MODIFICATION OF AN APPROVED WATER POLLUTION ABATEMENT PLAN

FOR TEXAS TITO'S

Prepared
October 20, 2023

ATTACHMENT "B"
Modification Description

SECTION A-A
NOT TO SCALE

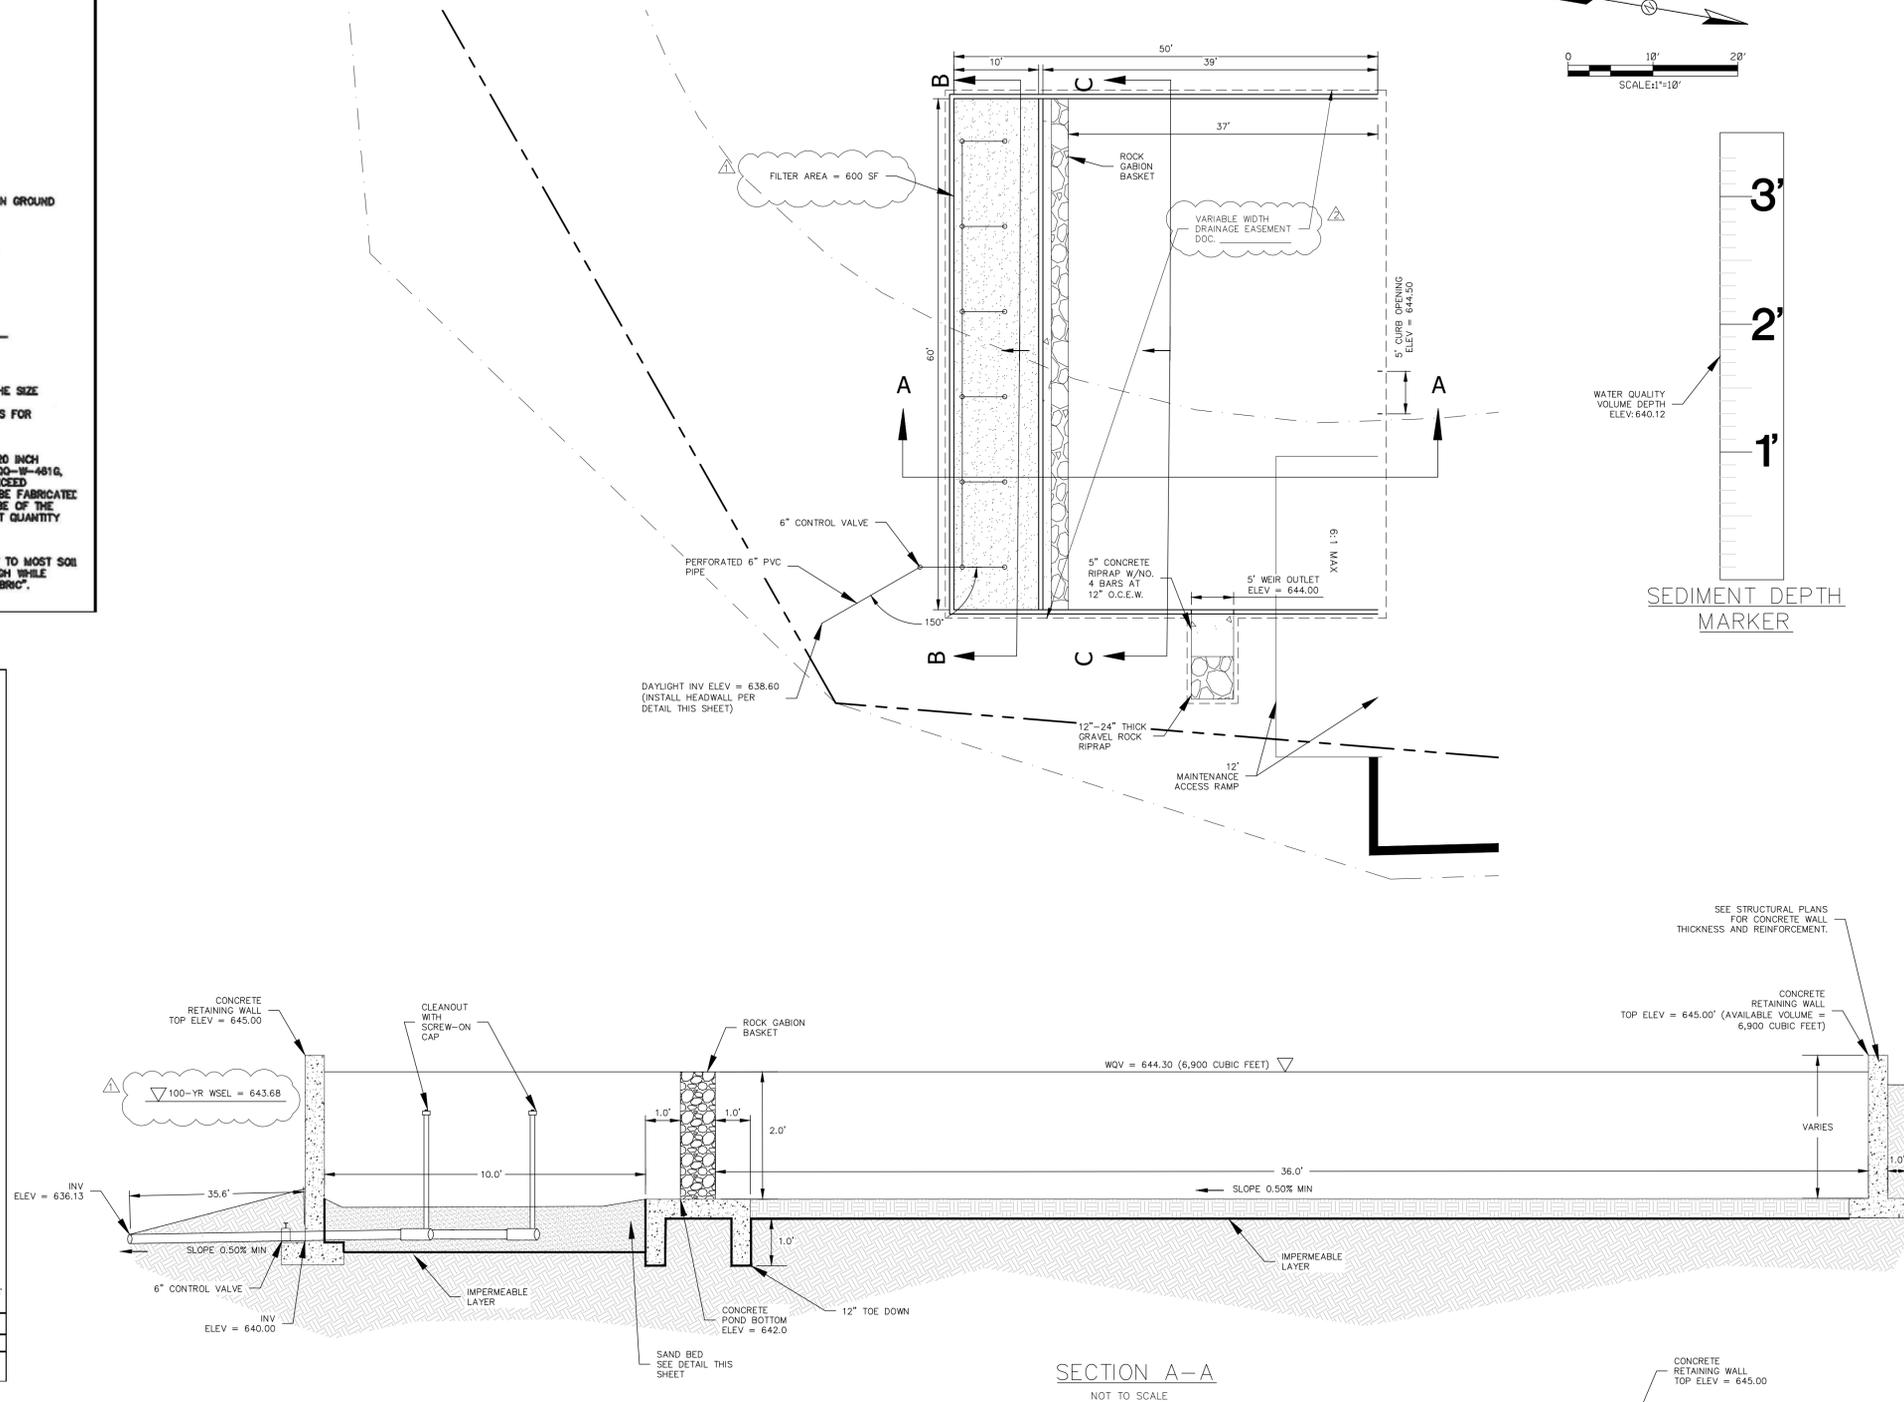
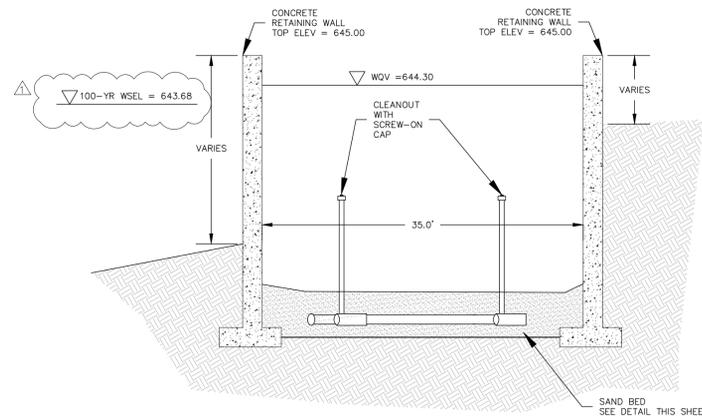
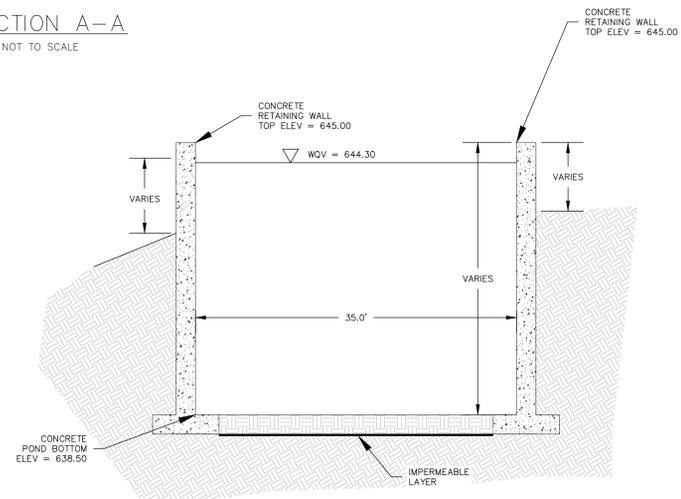
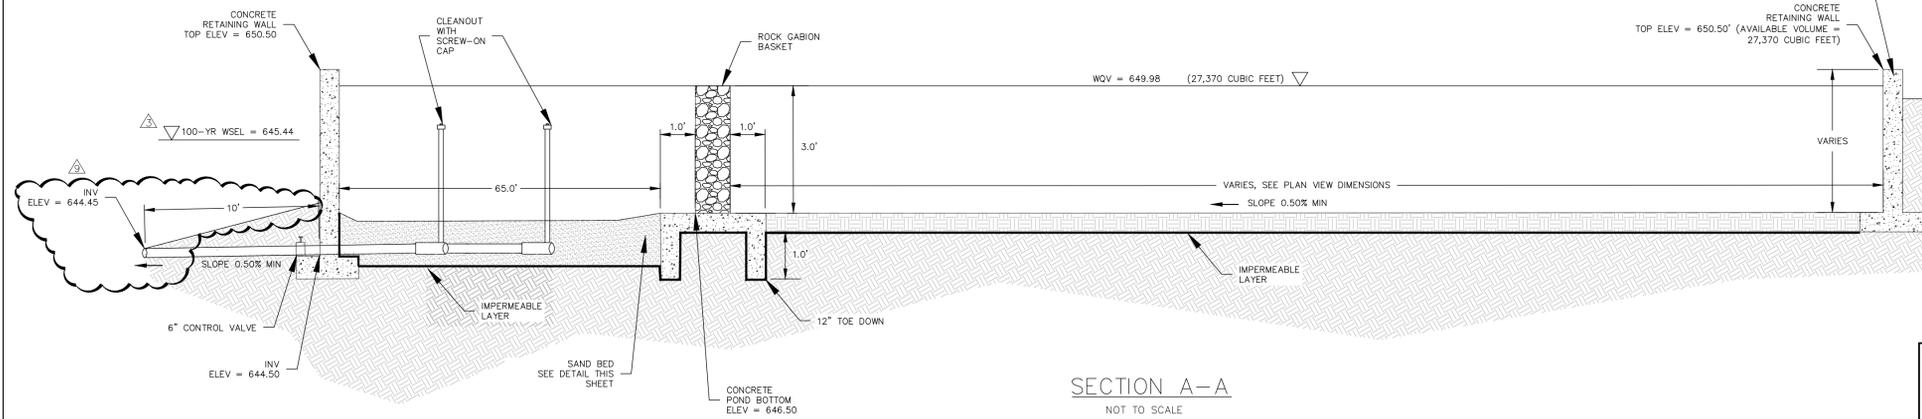
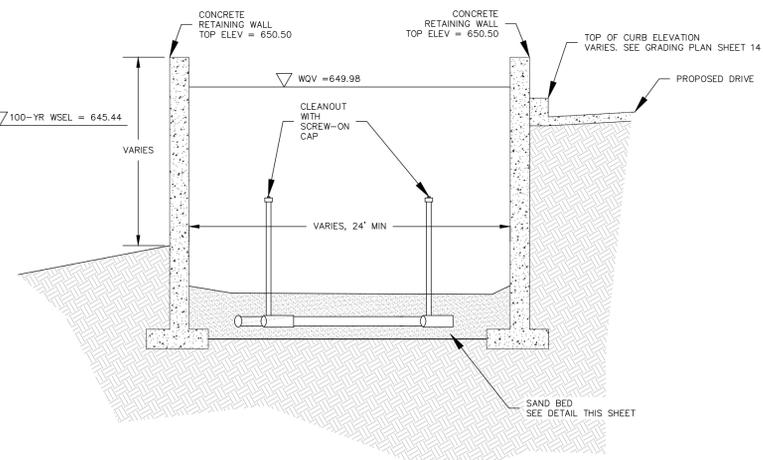
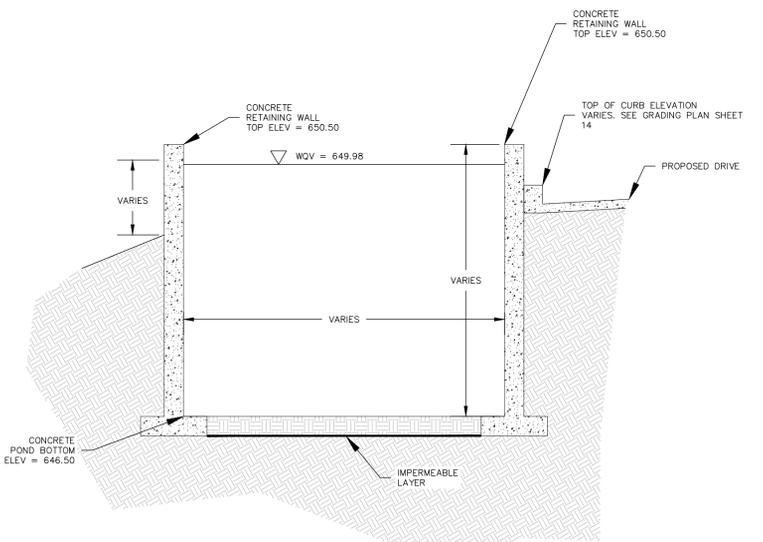
The modification to the approved WPAP is regarding the design specifications of the BMPs. In the approved plans, the sedimentation chamber was specified to be concrete bottom. It is in the interest of the owner to amend the plans to have earthen bottoms for the sedimentation chamber portion of the BMP. No further revisions to the plans are proposed.
